September 2, 2020

TO: Warrenton Planning Commission
FROM: Mark Barnes, Interim Planning Director
RE: Gilbert Gramson Variance (V20-02 and V20-03), Site Design Review (SDR20-07), and Subdivision (SUB20-01)

GRADING PLAN
 JUNIPER AVENUE SUBDIVISION
 JUNIPER AVE, WARRENTON, OR 97146

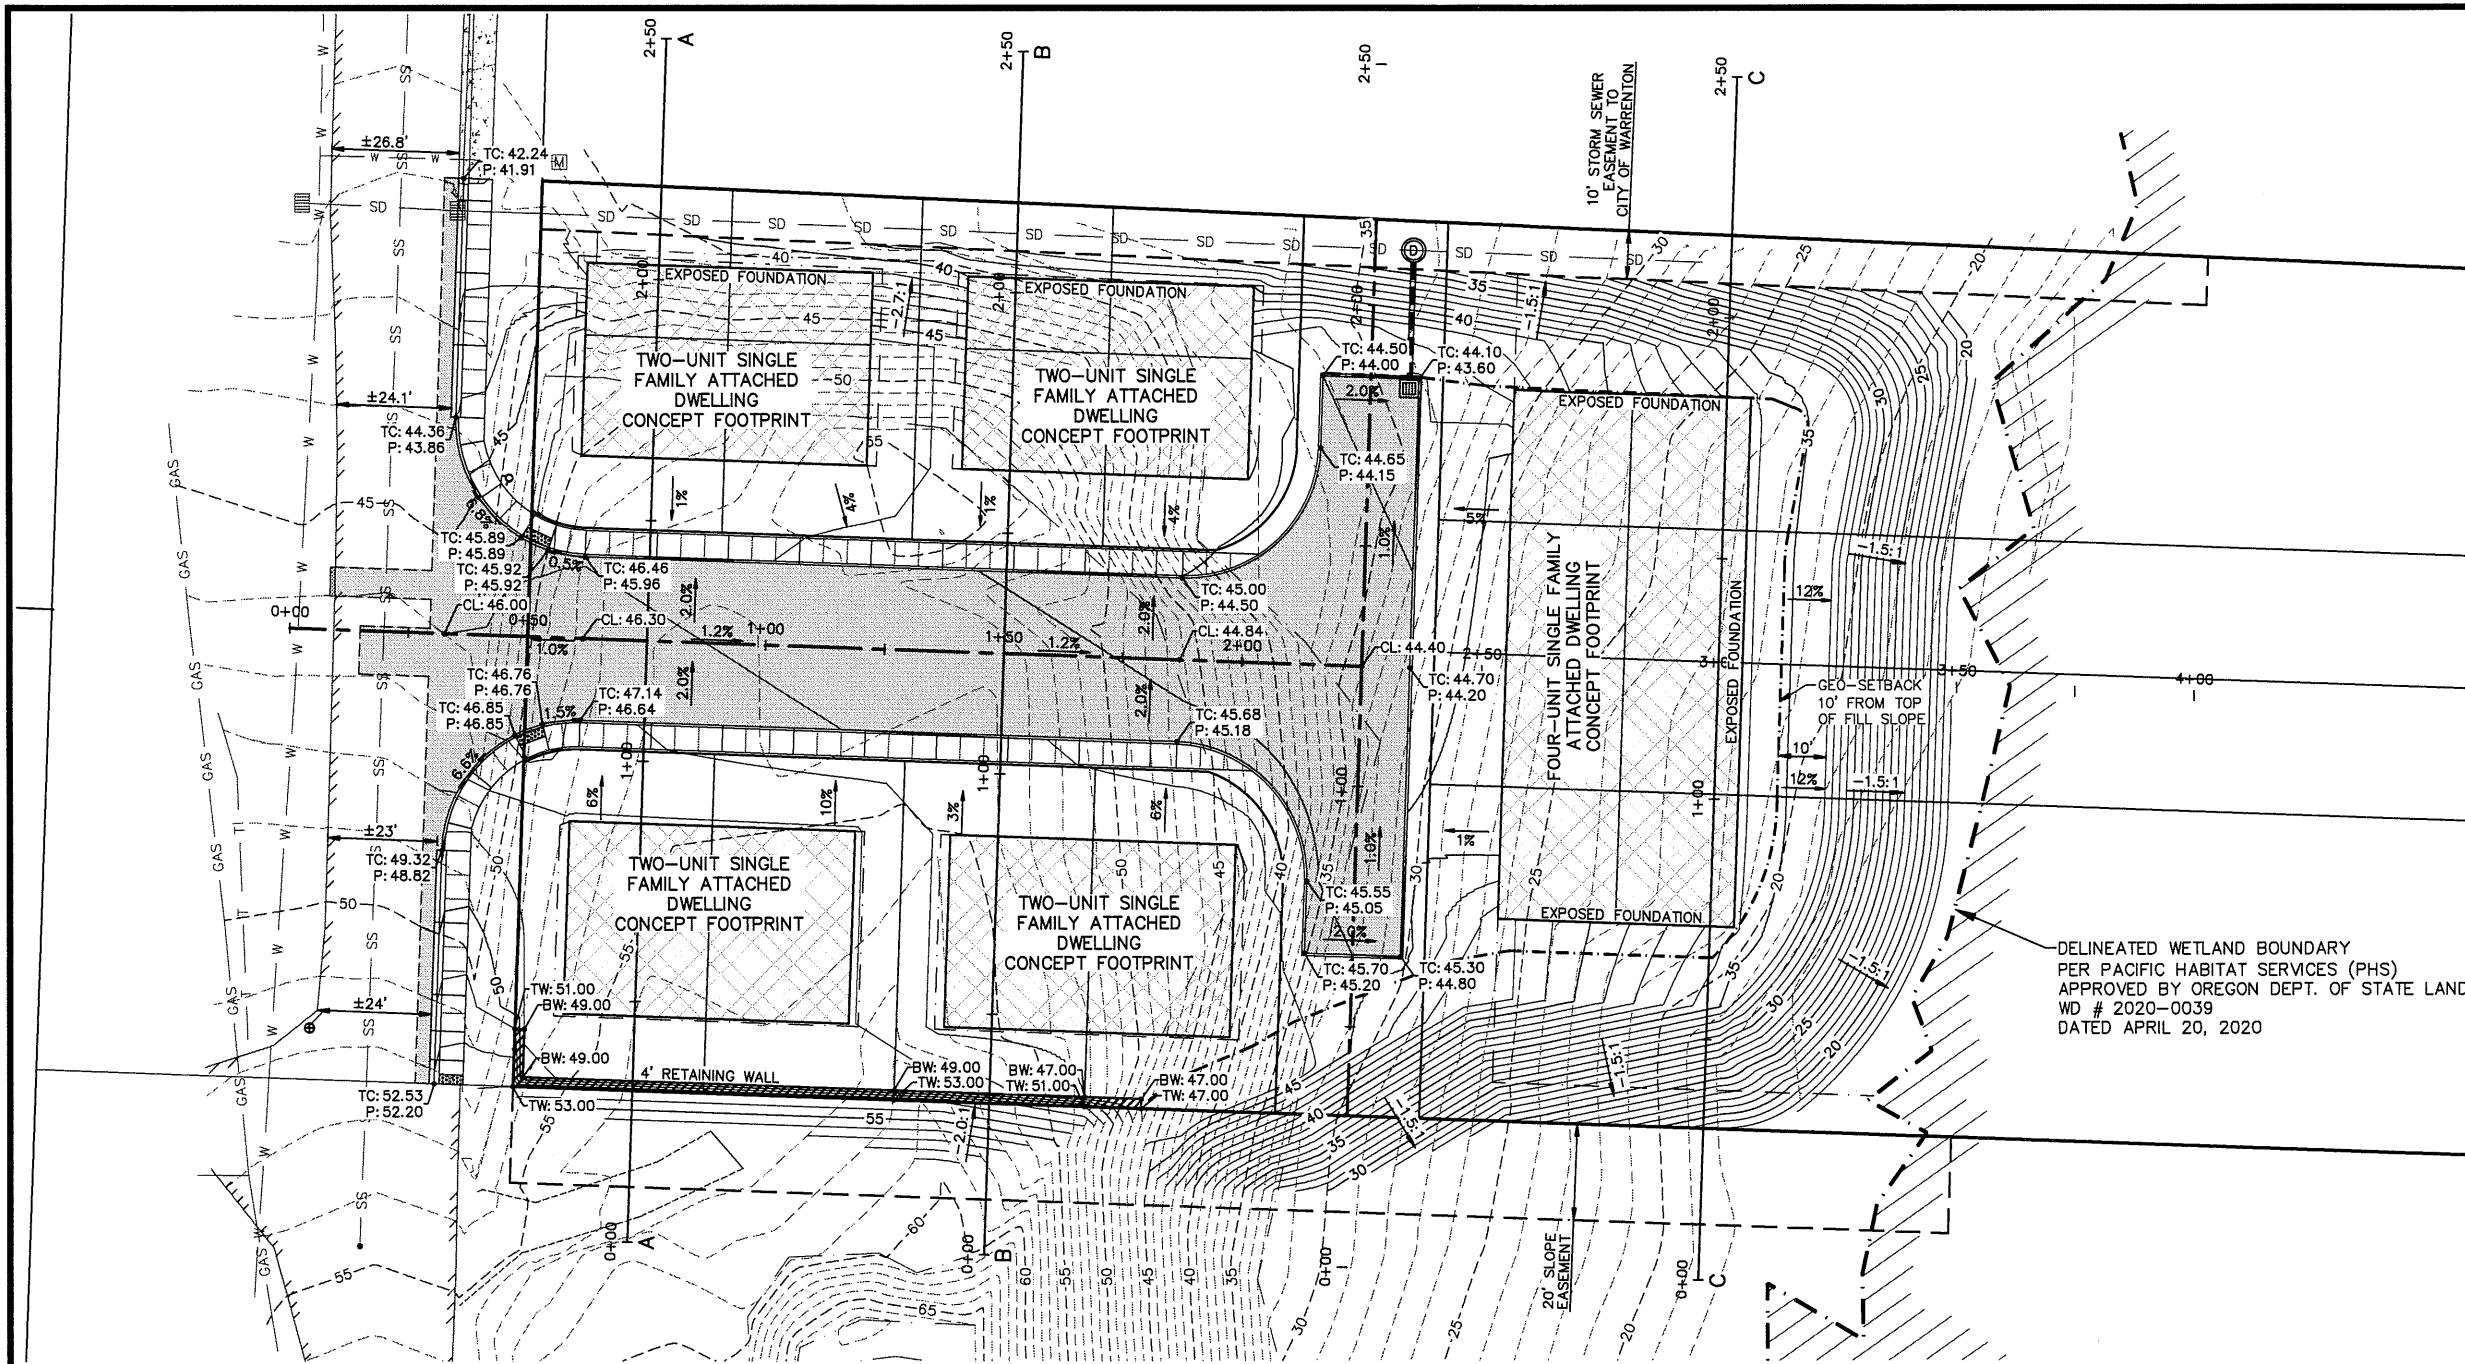
Engineered grading plans for the site were prepared by the applicant and are under review by the Public Works Department as of the date of this staff report. Sheets 4 and 5 of the preliminary plat plan-set illustrate the proposed final grading plan. Upon preliminary plat approval, the applicant will submit application for the final grading together with engineered construction plans for the public improvements before any construction begins.

CENTERLINE STA 0+75 - SECTION A-A

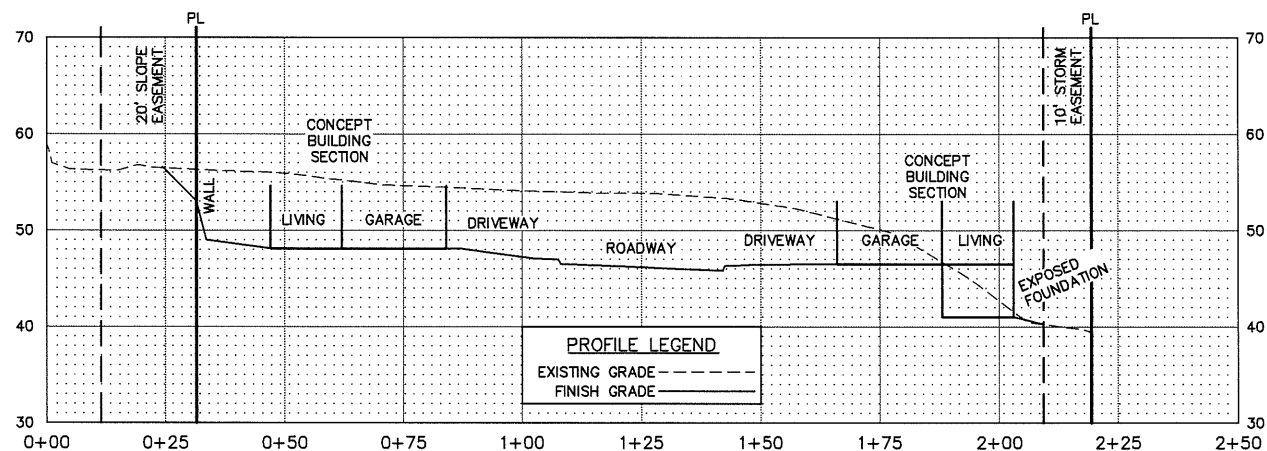
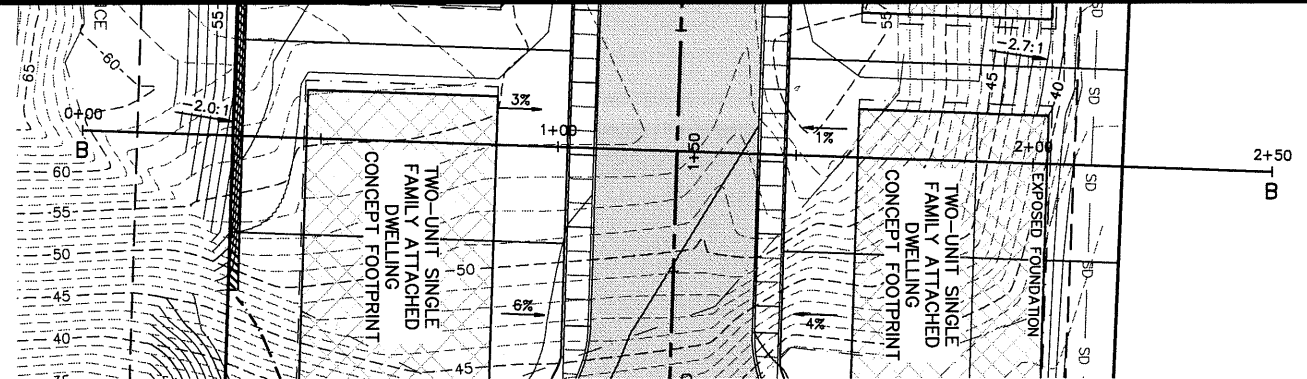
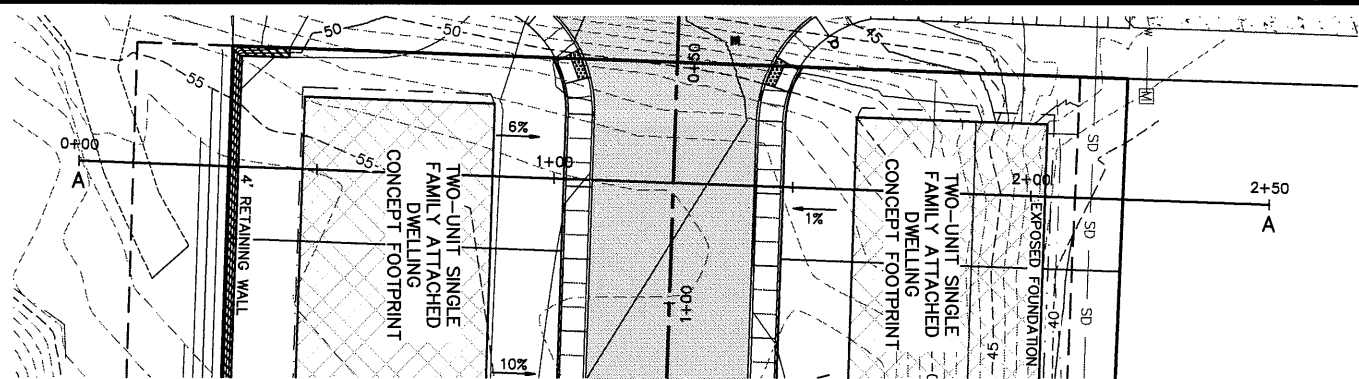
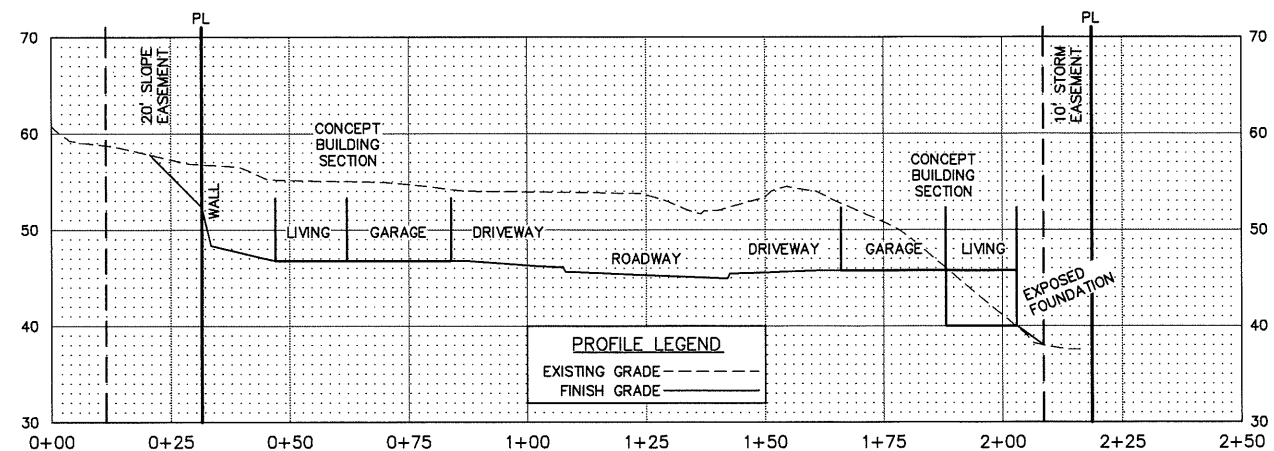
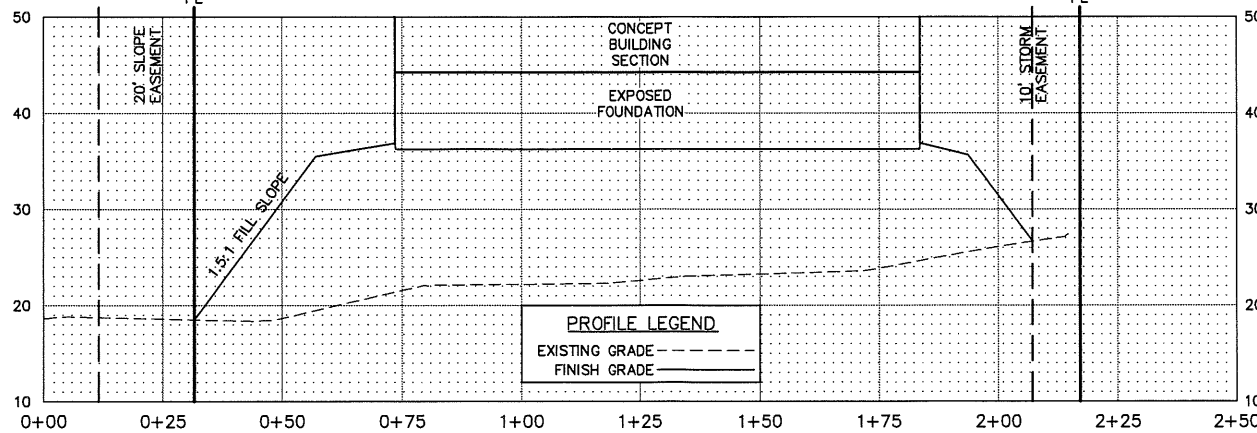
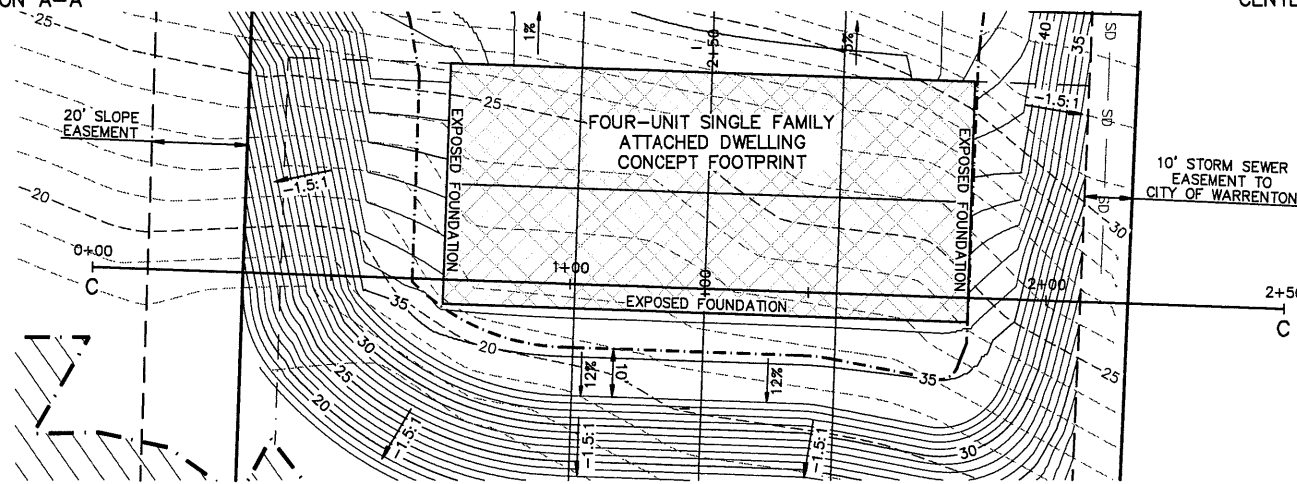
Suggested finding: Sheets 5 and 6 of the preliminary plan set illustrates the proposed cuts and fills. All earth movement designs are in compliance with the standards above or the geotechnical report.
